## canopy

Design Review, Type III Application  
LU 15-209365 DZM, AD  
September 15, 2015 Revision | ZGF Architects, LLP

# Applicant Response to DAR Summary

**N** Enlarged Plan | 1/4" = 1'-0"

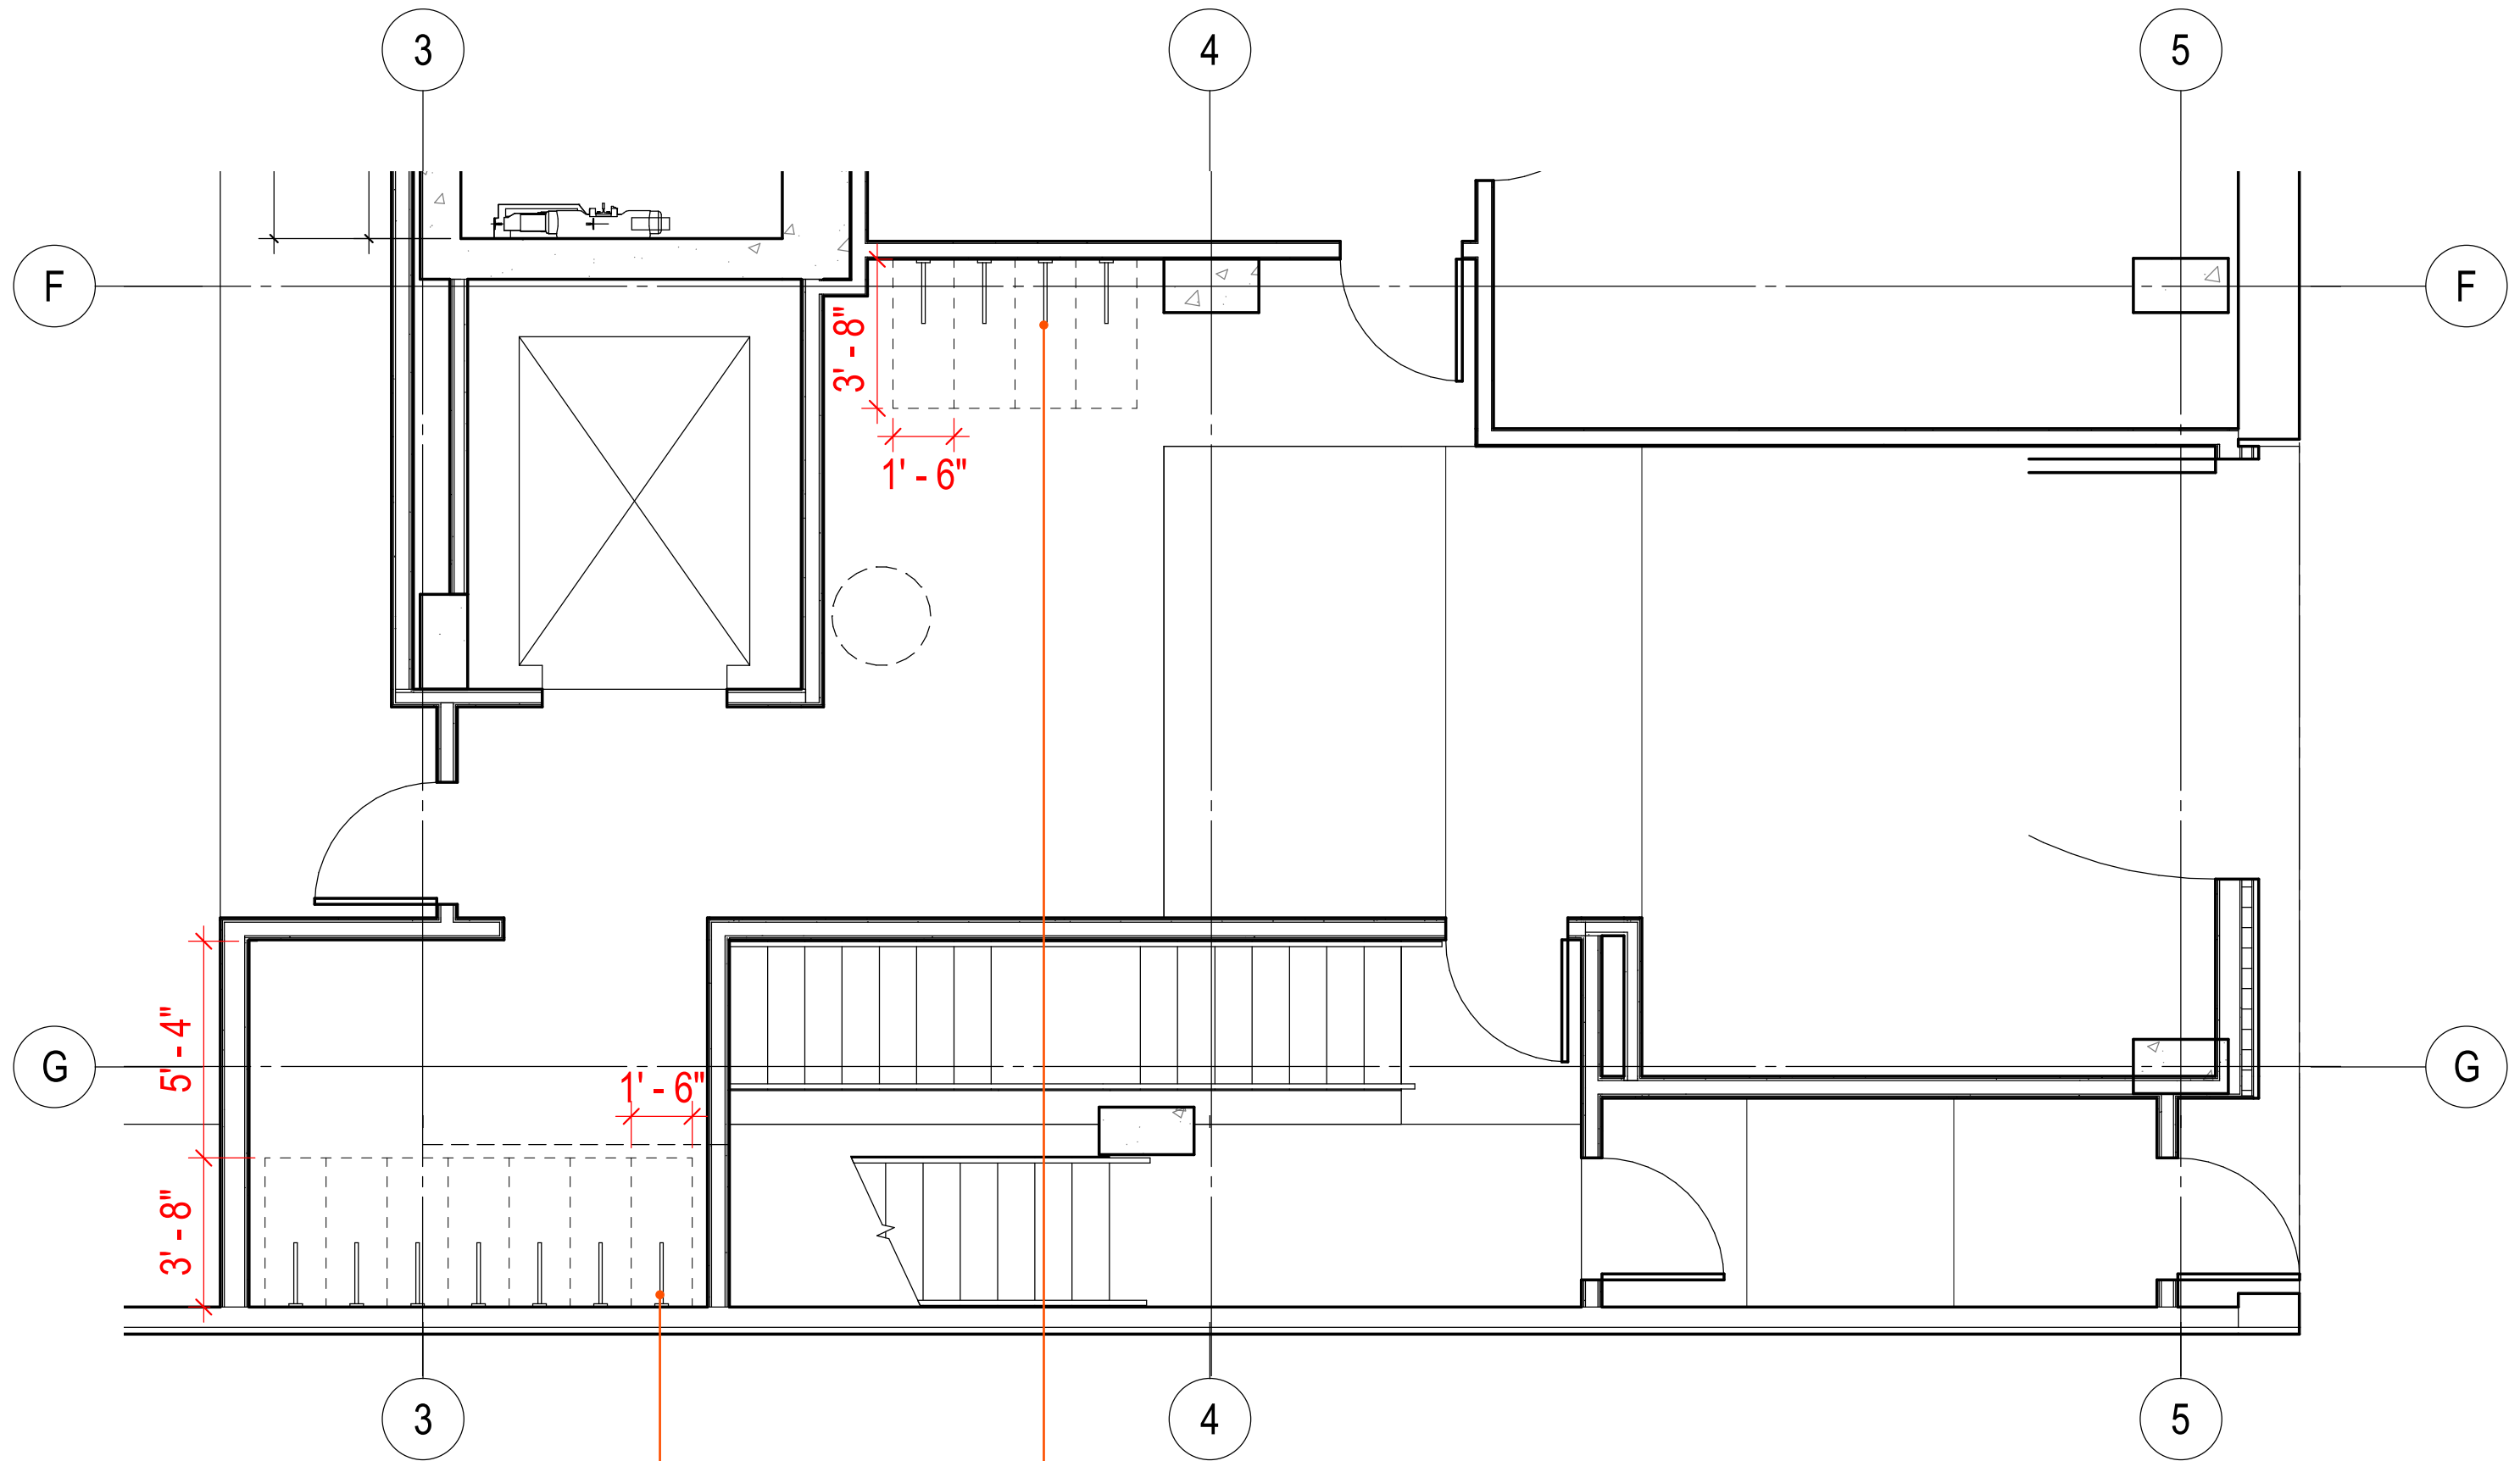
Wall-mounted Bike Racks,  
staggered 0'-10" vertically.
